RE: Mendocino Commentary CDP_2020-0024 (Boothe)
34350 Pacific Reefs Road
Albion, CA 95410
APN 123-340-13-00

Wynn Coastal Planning & Biology (WCPB) received commentary from the California Coastal Commission regarding the Boothe's Coastal Development Permit (CDP) Application. The CCC email is written by Supervising Analyst Melissa Kraemer and is dated June 17, 2021. The purpose of this response letter is to address requests in Ms. Kraemer's commentary regarding minimum monitoring requirements and success criteria for the headland wallflower MMRP recommended within Wynn Coastal Planning and Biology's biological report included as part of the CDP application.

Presumed ESHA Map with Proposed Development

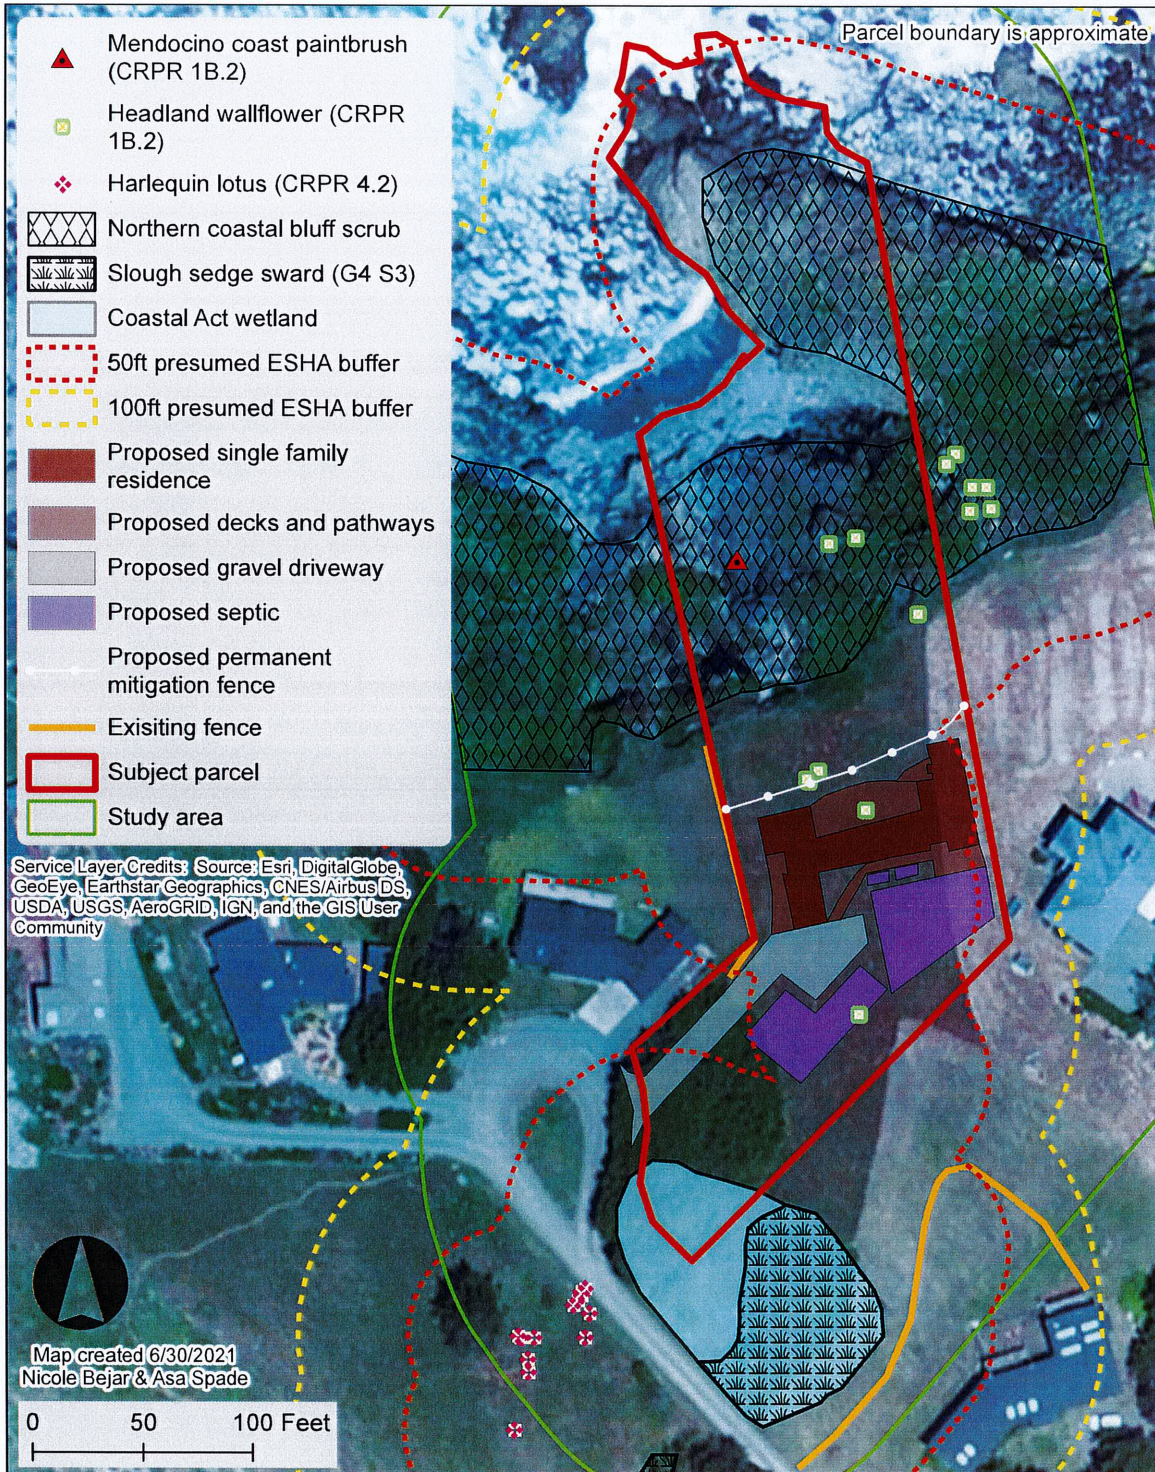
A low wooden or rope fence shall be installed, set back roughly 45 46ft, along paralleling the bluff edge to denote sensitive natural habitat to its north and to discourage entry into this area. This location for the fence is consistent with the geotechnical setback as reported by Brunsing and Associates, Inc. approximately the edge of the extent of the iceplant infestation at the time of the biological surveys, which will be converted to native habitat supporting headland wallflower. The area north of the permanent symbolic fence shall be maintained as native habitat.

A new version of the Presumed ESHA Map with Proposed Development (Figure 2 of the biological report) depicting the exclusionary fencing at 46ft from the bluff top, rather than the 15ft originally specified, is attached below. I hope this addresses all changes recommended by the Coastal Commission. Please let me know if you have additional questions.
